INVITATION TO BID (ITB) 10-015-23

1000 Skies-Sunrise Phase 2 Road Construction

Addendum Two

PIONEER ROAD TYPICAL SECTION - OVERLAY CONSTRUCTION

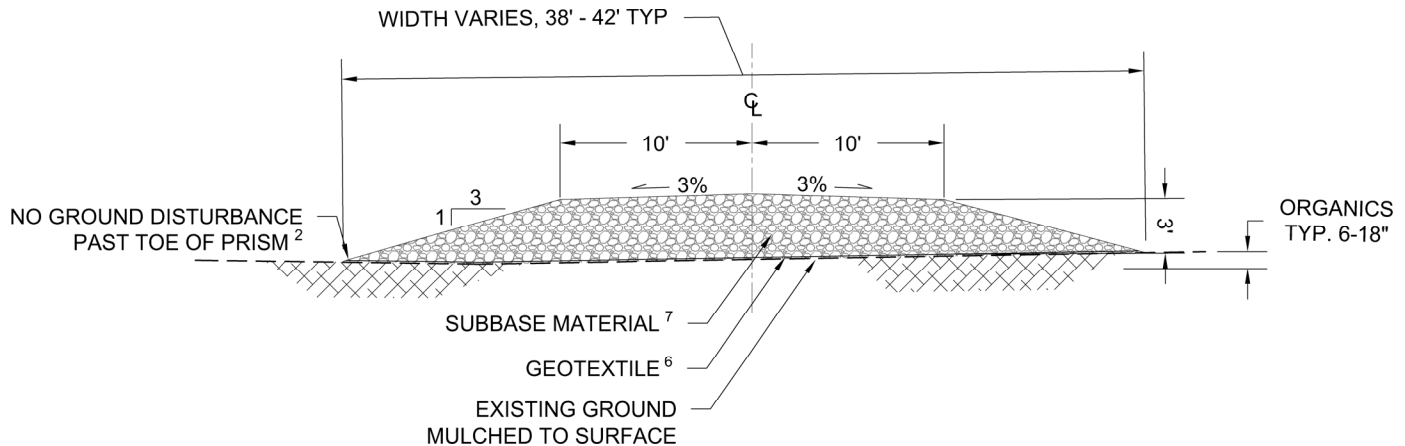
Question 2: Specify the type of Geotextile required in the Pioneer Road Typical #1, sheet 1 of 2, 6.). Please clarify requirement of a Type I, Reinforcement, woven or a Class I, Separation, woven. There is a significant price difference between the 2 types of Geosynthetics.

Question 3: Pioneer Road Typ. #1 indicates a road TYP disturbance width of 42’. Should that be 32’ +/-? Please clarify.

Answer: Reinforcement, Woven, Type 1 is intended.

Answer: Please see attached revised typical section dated March 6, 2023.
